**DATE:** December 22, 2010

**SUBJECT:** (2010-xxx) Grand Rounds Missing Link Regional Trail Master Plan,  
Minneapolis Park & Recreation Board (Referral No. 20523-1)

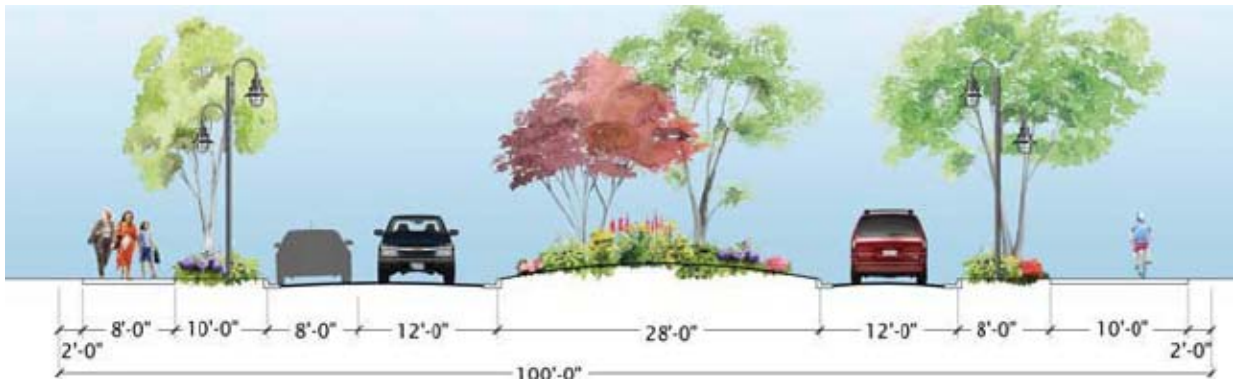
The Commission expressed concerns that the 100 foot ROW may include the parkway that is proposed in the master plan and that regional parks funding should not be spent for transportation purposes.

**Option A**—Future regional parks funding for land acquisition should be related to the proportion of the site used for the regional trail, based on a strip of right-of-way not to exceed a width of 68 feet.

The master plan included a typical cross-section for a 100 foot right-of-way, assuming that the regional trail would parallel the parkway. This cross-section is depicted on the following graphic:

Within this 100 foot ROW, 32 feet is dedicated to the roadway—there are two 12 foot travel lanes and an 8 foot wide parking lane. There are separate pedestrian and biking trails, which, along with the associated greenspace, comprise 68 feet of the corridor.

**Option B**—Future regional parks funding for land acquisition should be related to the proportion of the site used for the regional trail, based on a strip of right-of-way not to exceed a width of 50 feet.

In response to the MPOSC discussions and to Option A, Councilmember Wulff suggested that the ROW eligible for regional parks funding be based on a maximum corridor width of 50 feet, since a municipality typically owns ROW outside of the paved roadway area.

In response to your email dated 12/16/2010, with regard to the two proposals (68' and 50') the Park Board would favor the 68' width dedicated to the trail portion of the 100' corridor. To help clarify our position I offer the following reasons. First, the existing parkway system and proposed parkway are different than an ordinary street. Parkway systems are not considered, nor are they, street right-of-ways. A parkway is a road within a park. If one were to look at a plat book, you would see street ROW for normal city streets but for the parkways there would be just the lot lines of Park Board ownership. Thus, the width for the parkway varies according to the surrounding park. Examples include - St. Anthony Parkway with a width of 100 feet; Victory Parkway with a maximum width of 300 feet. Minnehaha Parkway has a great deal of varying width. These varying widths, along with the surrounding natural and cultural resources, give a significant character and appeal to each parkway. The amount of green space and natural surroundings identify the parkway corridor and separate the parkway from a 'typical' street ROW.

Second, the parkway system is narrower than most streets or roadways. The vehicular travel cross-section is 24', 11' bituminous travel lanes and 1' concrete gutter. The parking bays are 8' wide and are spaced minimally throughout the parkway system and are usually on only one side of the parkway. Thus a maximum cross-section is 40' but a more common width is 24 - 32'. As such, in a 100' ROW scenario, the area allowed for open space and trail use would be 68 - 76 feet.
